### Staff Report – The Courtyards at Jerome Village AKA GPN-5 P8

Staff Analysis:	This Final Plat involves 8.242 acres of land and proposes 36 lots. Of those lots, the Final Plat proposes 30 single-family residential lots and 6 duplex dwellings (total of 6 units) on 6 lots.
	Acreages:  o 1.655 acres in <i>private</i> right-of-way o 4.193 acres in lots o 2.394 acres in open space
	Proposed utilities:
	Preliminary Plat:  o The Preliminary Plat was approved on 03-10-16. It was shown as three phases. However, this Final Plat is only a <i>portion</i> of Phase 3.
	<ul> <li>Union County Engineer's Office</li> <li>The Engineer's Office submitted comments in a letter dated 12-06-17. The Engineer's Office did not</li> </ul>

RE.: The Courtyards at Jerome Village Phase 8 AKA Glacier Park Neighborhood Section 5 (GPN-5) Phase 8 – Final Plat

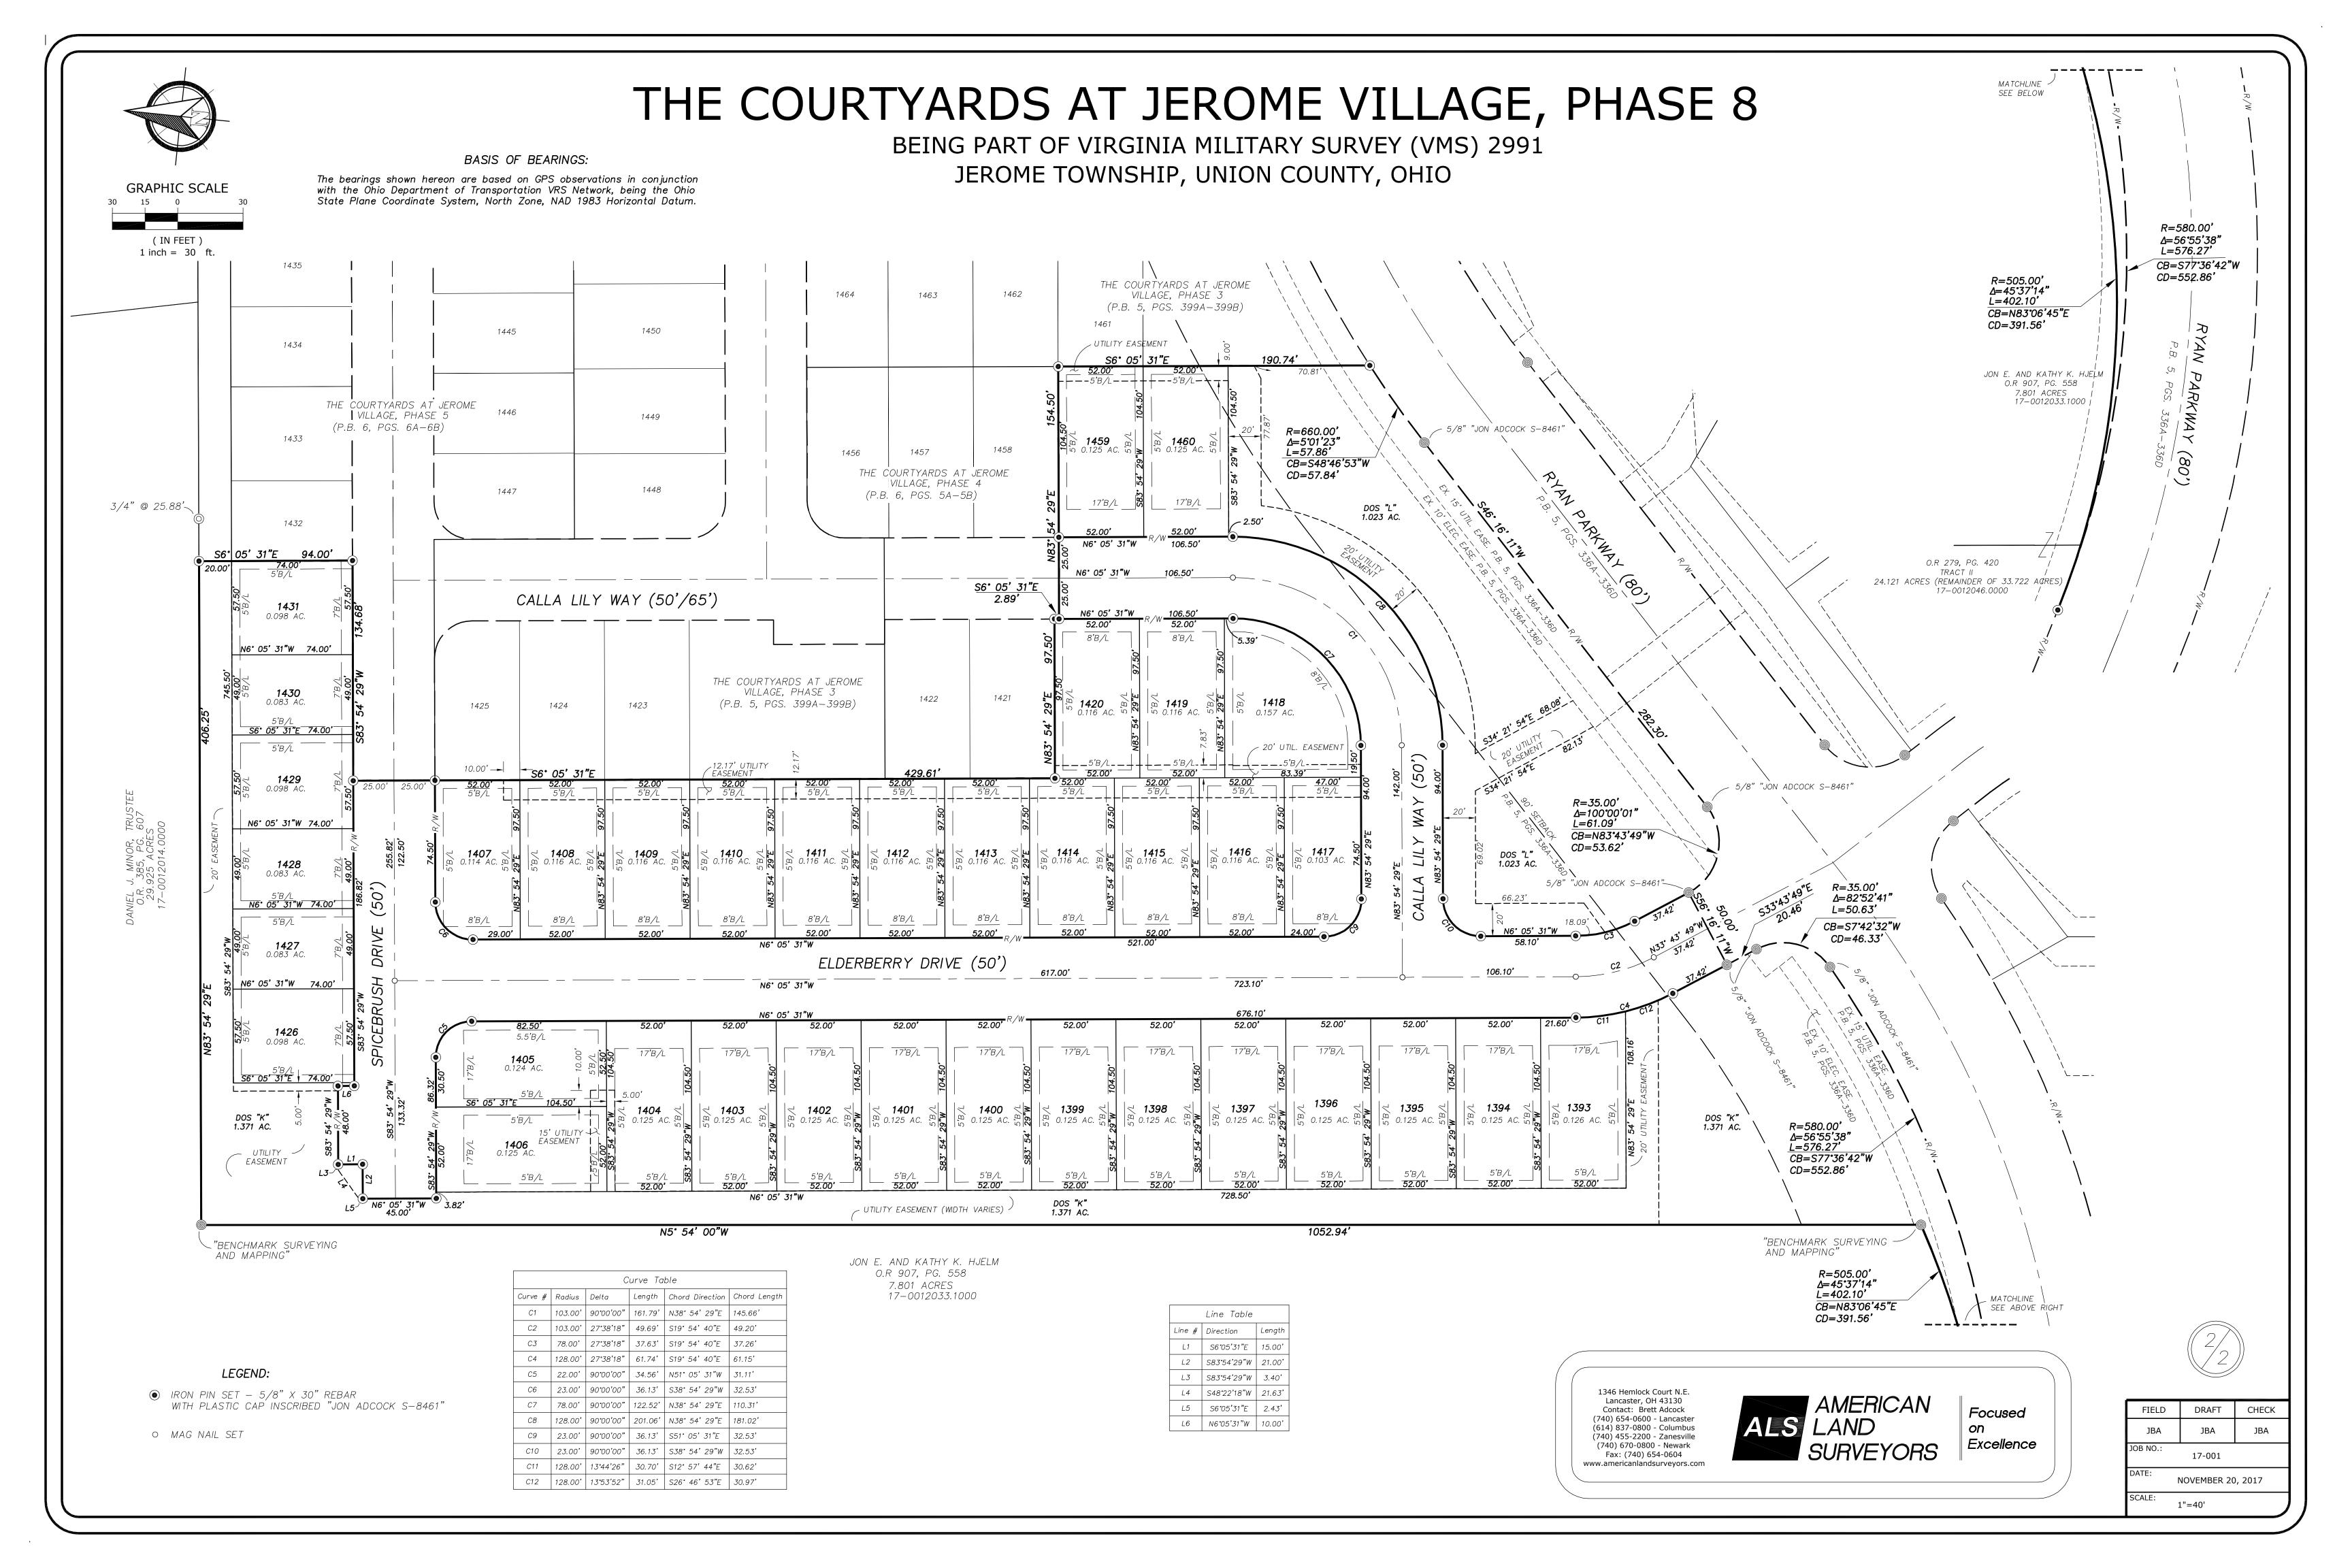
- o URE submitted comments in a letter dated 12-06-17.
  - 1. Request easement width to be defined along rear lots 1393 through 1404 and 1406. Require dimensions when we need to discuss easement locations with our members. Also, at end of Spicebrush Drive.

- 1. Sheet 1: Please double-check density calculations and adjust if warranted.
- 2. Sheet 2: Written and graphic scale shown as 30' at top of sheet and 40' at bottom of sheet. Please correct (§323, 1.).

- 3. Sheet 2: Easements for water and sewer must be a minimum of 20' and 10' for other utilities. See easement between lots 1404 and 1406 (§313, 12.; §414).

- 4. Sheet 2: Preliminary plat comments included extending the west-east easement through lots 1405 and 1404 to Elderberry Drive. Is this still intended (§320)?

- 5. Sheet 2: In DOS "L", there is an easement running between Calla Lily Way and Ryan Parkway that abruptly stops. Is additional detail needed (§313, 12.)?

Enc: Final Plat Markups

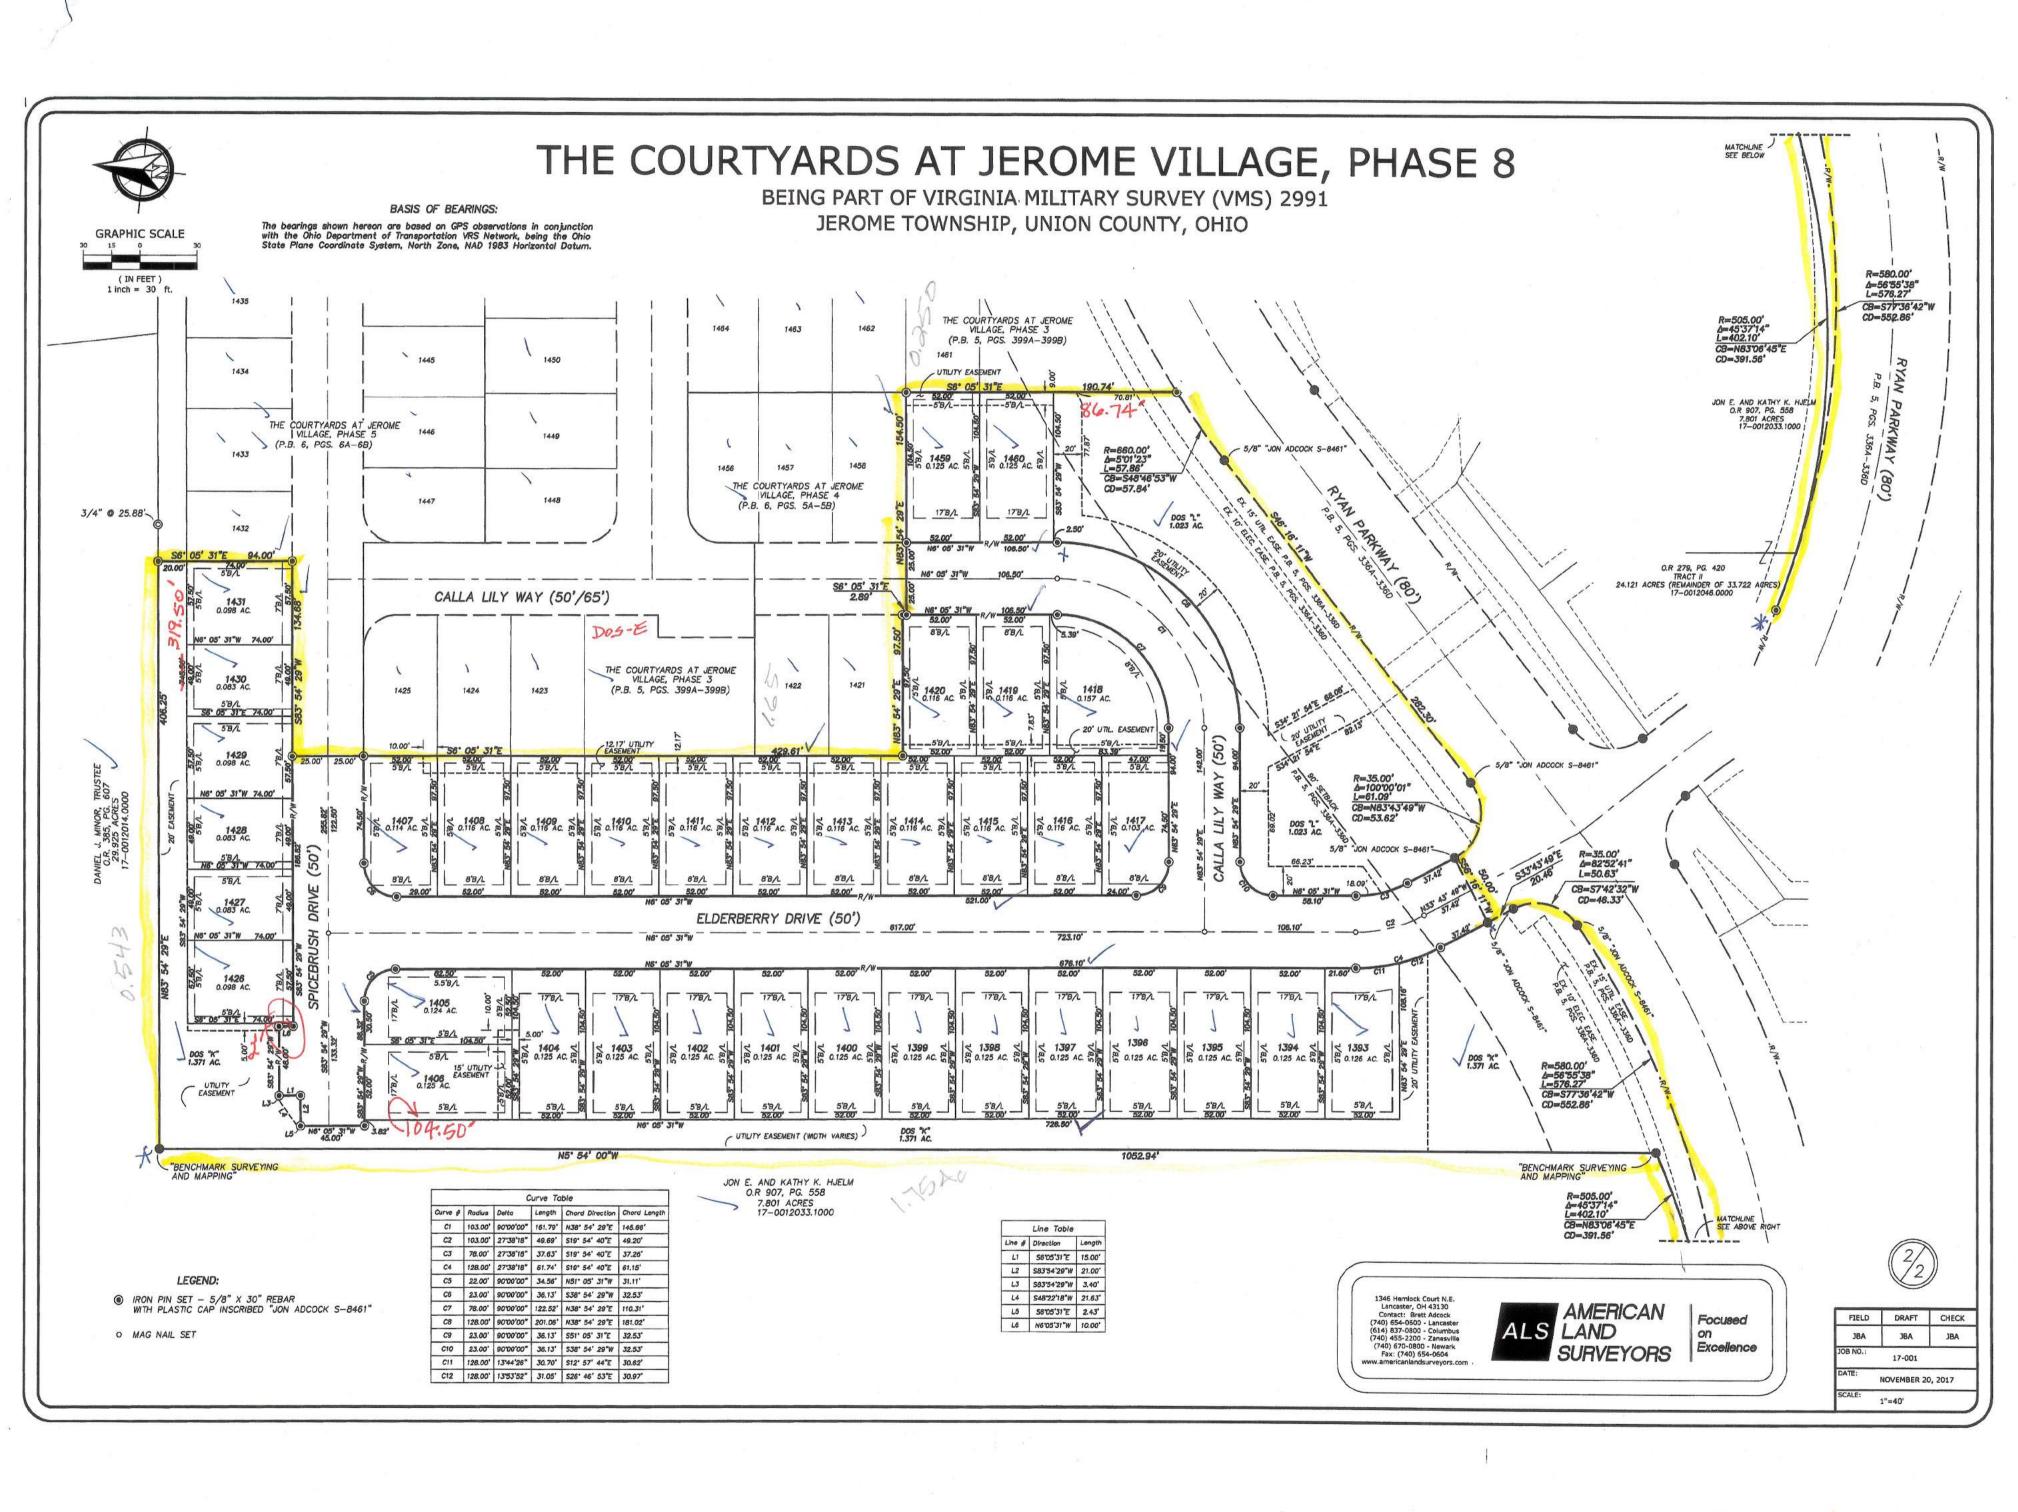
We have completed our review for the above final plat, received by our office on November 27, 2017. The construction drawings have been approved by our office. Construction work has commenced on site, but has not been completed. As such, we have requested and received a performance bond for improvements shown on the plat. Our Prosecutor's Office is in the process of reviewing the performance bond and we anticipate gaining Commissioners approval prior to the Executive Committee meeting. We also have technical comments from our review of this plat, which I have attached along with this letter.

Due to the outstanding comments, we do not feel comfortable issuing an endorsement of approval at this time. However, due to the nature of the comments, we feel that they can be addressed by the December 14<sup>th</sup> Zoning and Subdivision Committee/Executive Committee meetings. I will keep you updated on the status of the above outstanding comments and issue correspondence of approval when these items are addressed. If you have any questions or concerns, feel free to contact me at (937) 645-3165.
